# Access Compliance Report

## Public Rights-of-Way

| Intersection ID: 5935                   | Main Street: MALLARD_CREEK_RD | Cross Street: W_SUGAR_CREEK_RD          | Location: NE           |
| ADA ID: EC6CC135C6DD                    | Curb Cut Type: IslandRefuge2  | Initial Pass/Fail: Pass                 | Overall Compliance: No |

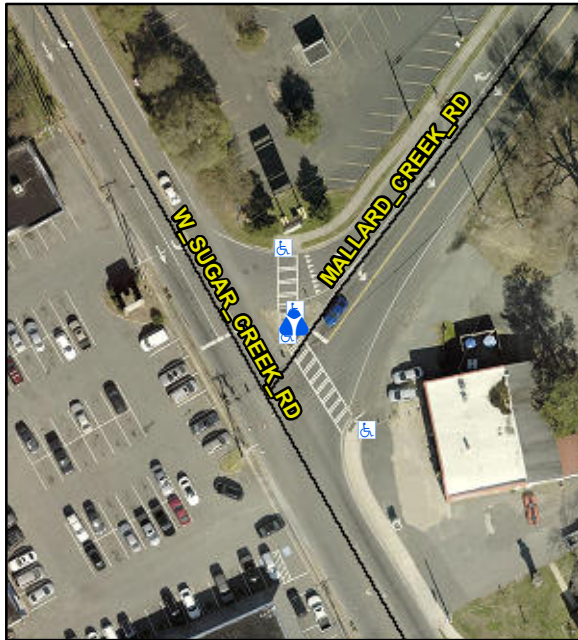
| Compliance | Description          | Data  | Compliance | Description                 | Data |
|------------|----------------------|-------|------------|-----------------------------|------|
| Yes        | Refuge 2 Slope (%)   | 3.0   | No         | Gutter 2 Slope (%)          | 8.8  |
| Yes        | Refuge 2 X Slope (%) | 1.1   | No         | Gutter 2 X Slope (%)        | 2.3  |

**Remove & Replace Gutter.**

Total Cost: \$ 750.00
